FEDERAL TRADE COMMISSION

Energy Labeling Rule

ACTION: Final rule; correction.

SUMMARY: The Federal Trade Commission (''Commission'') is correcting a final rule published in the **Federal Register** of August 12, 2014, which amends the Energy Labeling Rule by updating comparability ranges for certain heating and cooling products and making conforming changes to the Rule's sample labels.

Prototype Label 3 – Single-Package Central Air Conditioner (models manufactured after the compliance date of DOE regional efficiency standards in 10 CFR part 430)

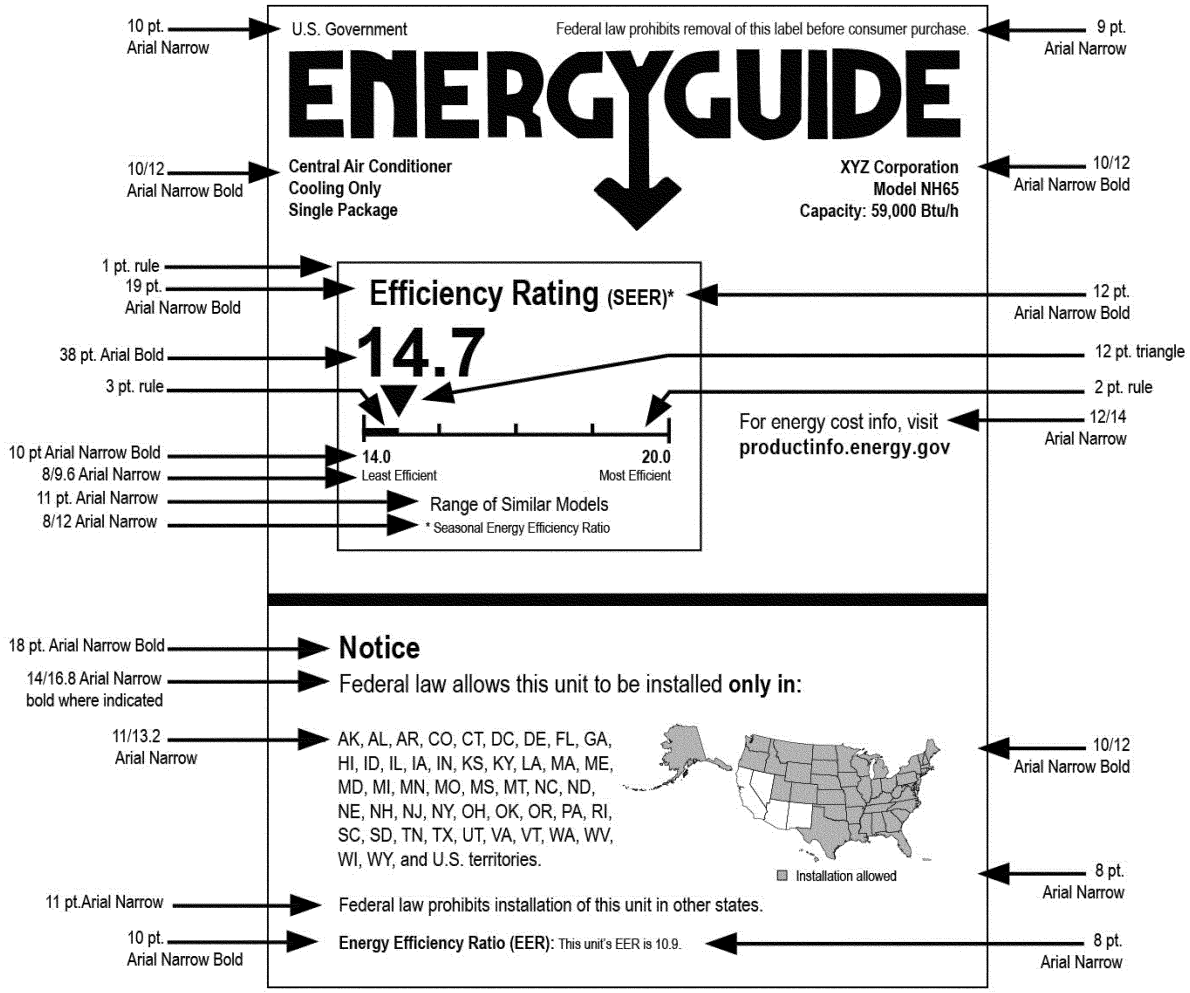
■ 3. On pages 46988 through 46992, Prototype Labels 3 and 4 and Sample Labels 7, 7A, and 8 are corrected to read as follows:
